# YARMOUTH MAINE

## Planning Board Report Railroad Square Master Plan Phase 1 Preliminary Review for Major Site Plan Review and Building & Lot Plan Railroad Square of Yarmouth, LLC, Applicant Map 37 Lots 28 and 29A; CD4 Village Center Character District Prepared by Erin Zwirko, Director of Planning and Development Report Date: November 7, 2024; Planning Board Date: November 13, 2024

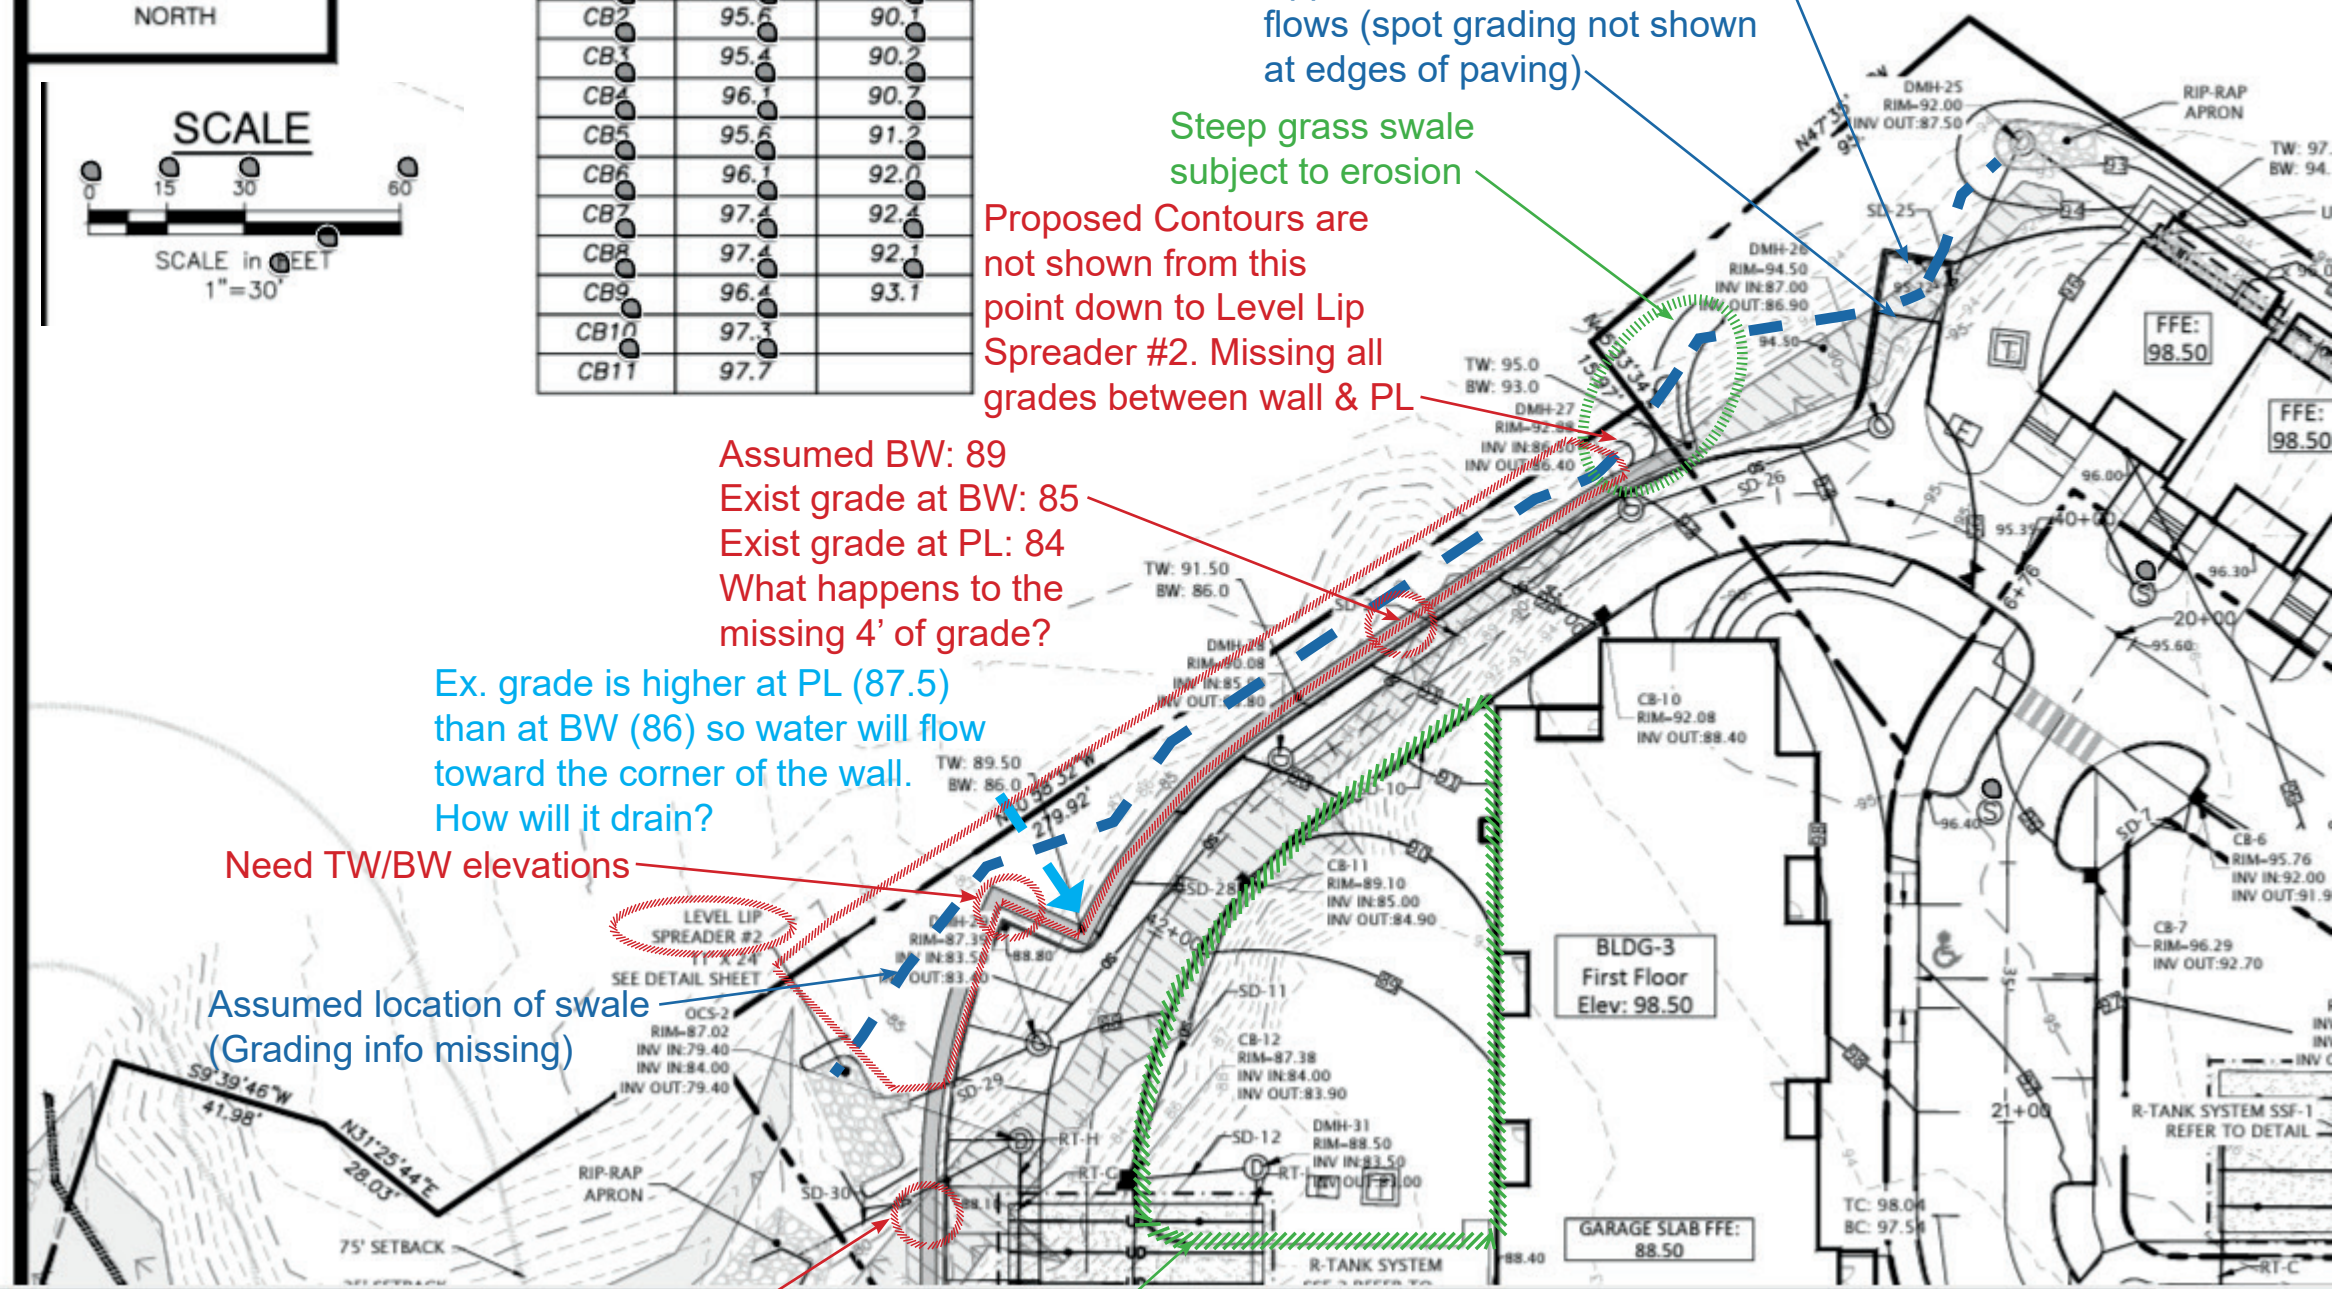
Proposed Contours are not shown from this point down to Level Lip Spreader #2. Missing all grades between wall & PL

Assumed BW: 89  
Exist grade at BW: 85  
Exist grade at PL: 84  
What happens to the missing 4' of grade?

Ex. grade is higher at PL (87.5) than at BW (86) so water will flow toward the corner of the wall. How will it drain?

Need TW/BW elevations

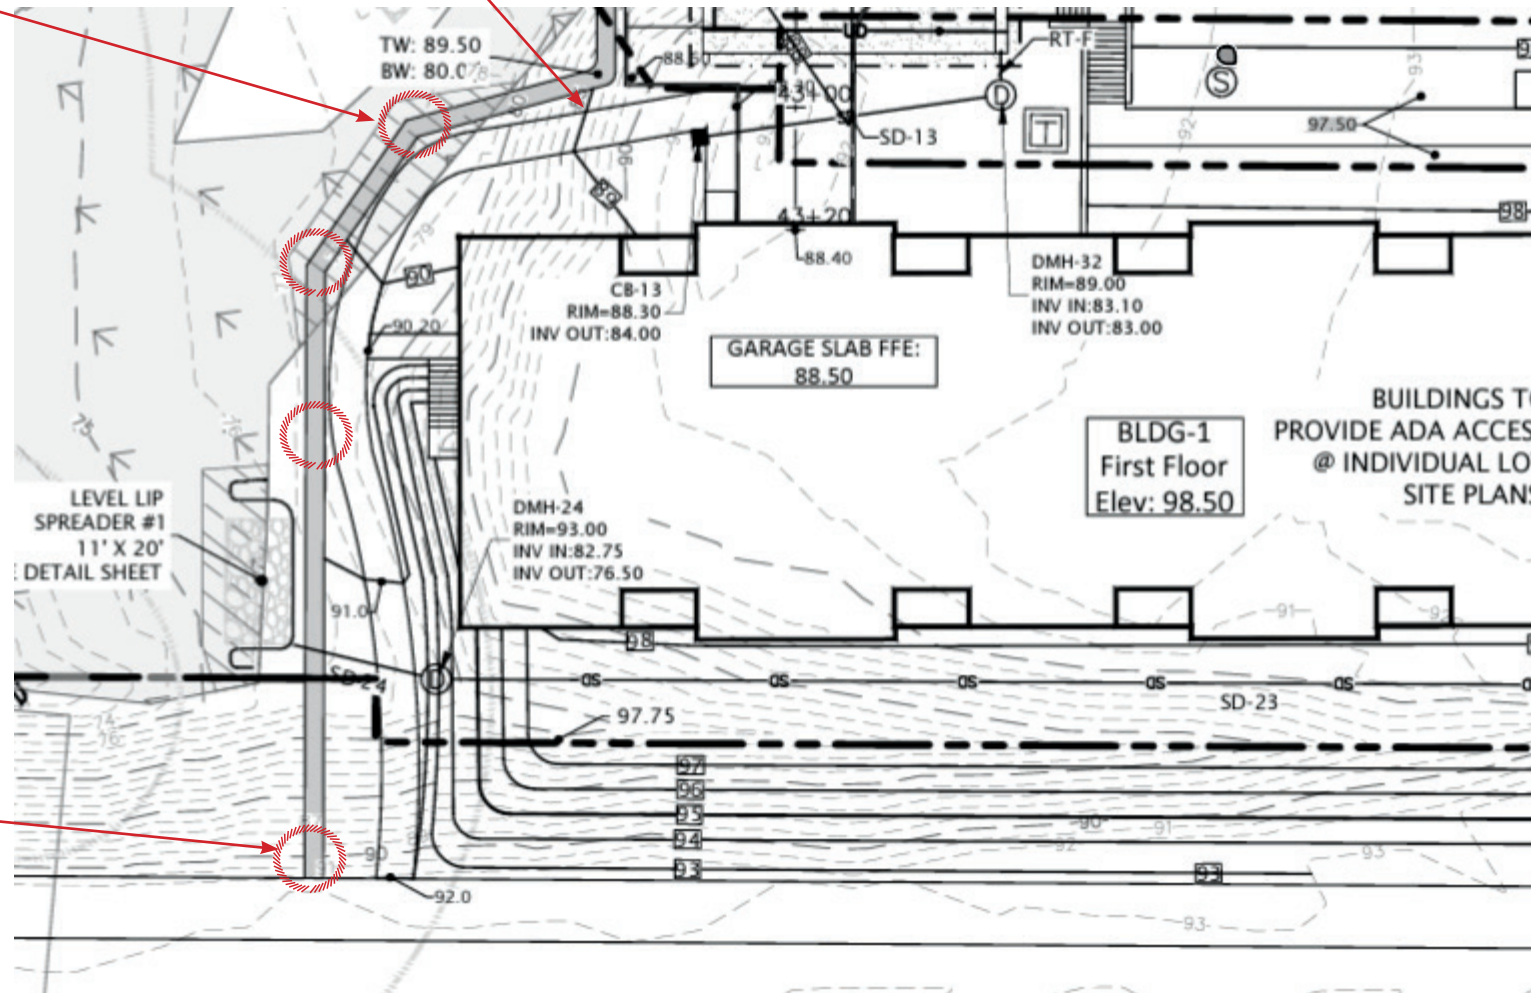
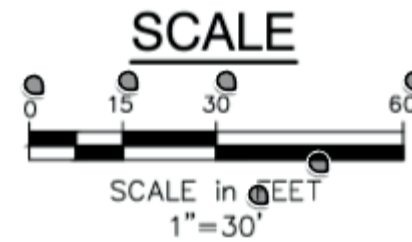
The retaining wall is 6" curb height at this walking path (89.5 TW, 89 at walk).

There is a 9.5' drop on the back side of this wall at the wetland. If you trip here, you fall 9.5.' How does this meet code? Is there a guardrail on top of the wall?

Need TW/BW elevations to understand impacts on wetland

Need TW/BW elevations to understand impacts on wetland
